Transmittal  
DATE: 03/13/2018  
PROJECT NO: The Legacy at Jordan Lake  
Prel Plat Re-Submission  
Phase 5A3 (15 Lots)  
Chatham County, NC

Re: The Legacy at Jordan Lake Phase 5A3

### Differences Between Current Layout and 2017 CUP

**THE LEGACY - PHASE 5 & 6**  
CHATHAM COUNTY, NC  
**OPEN SPACE EXHIBIT**  
03/12/2018

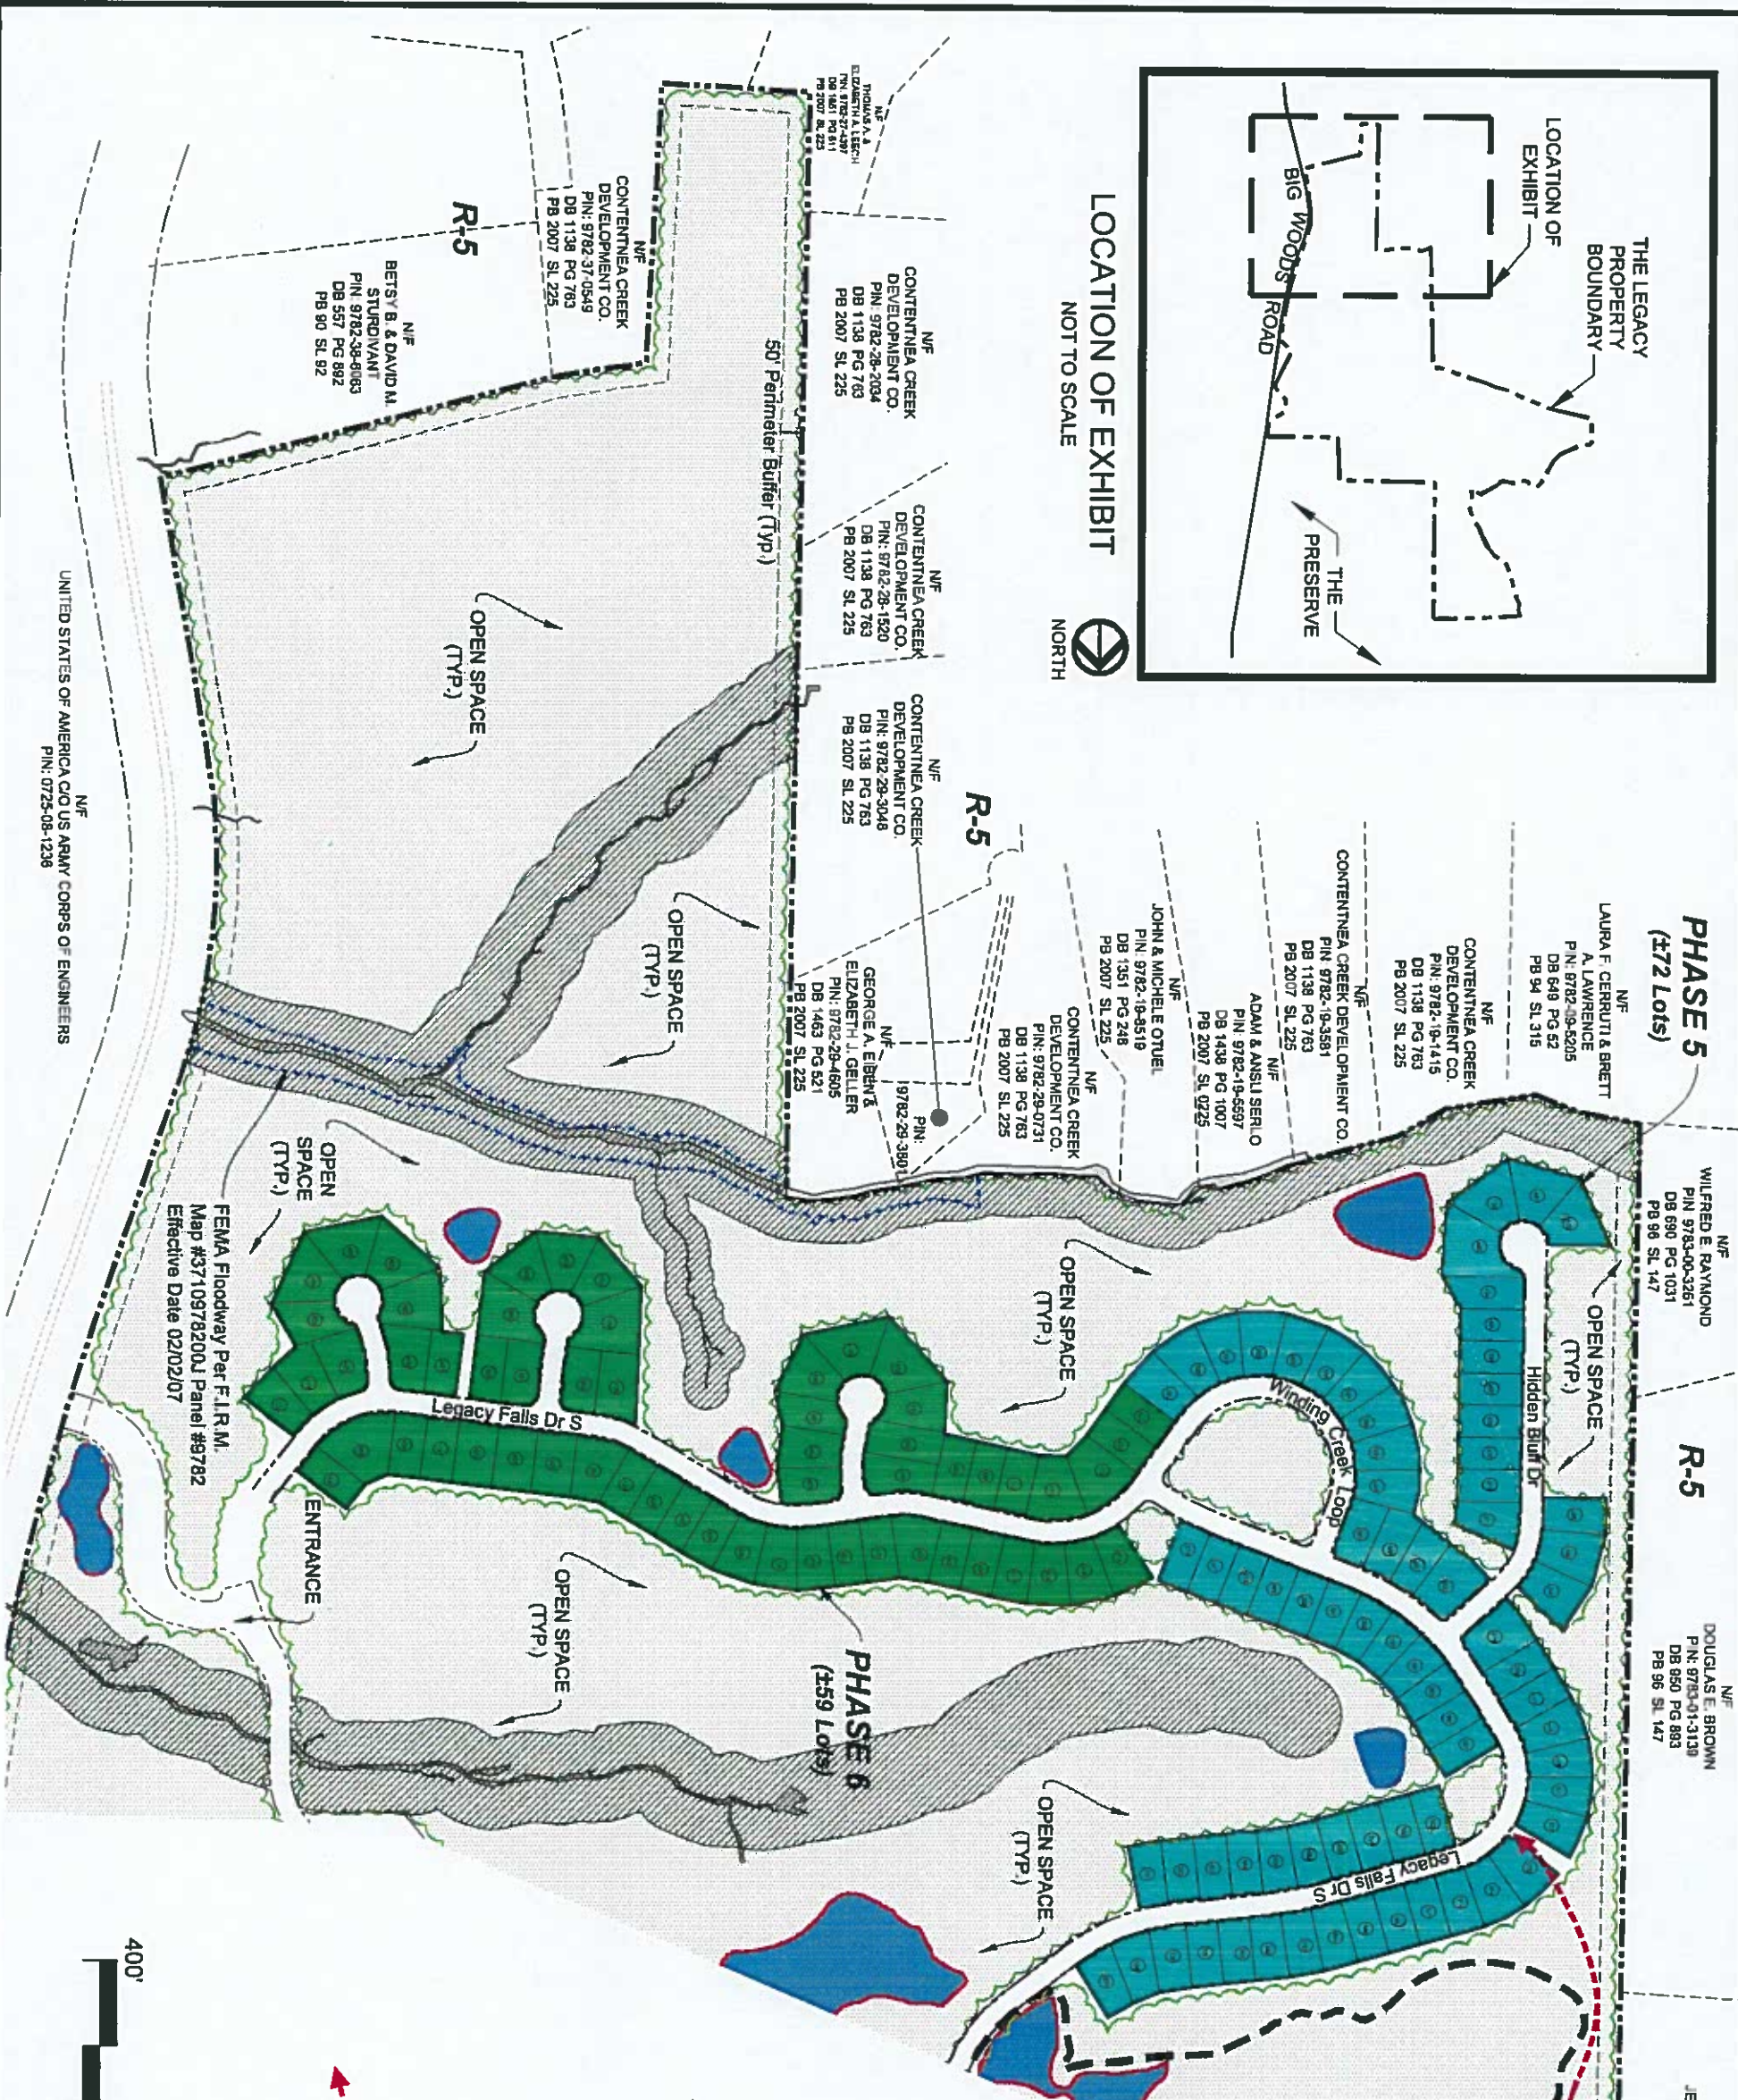
**Additional Note:** The space between lots 399 and 400 in the will be dedicated as Open Space as shown on the 03/12/2018 Open Space Exhibit.
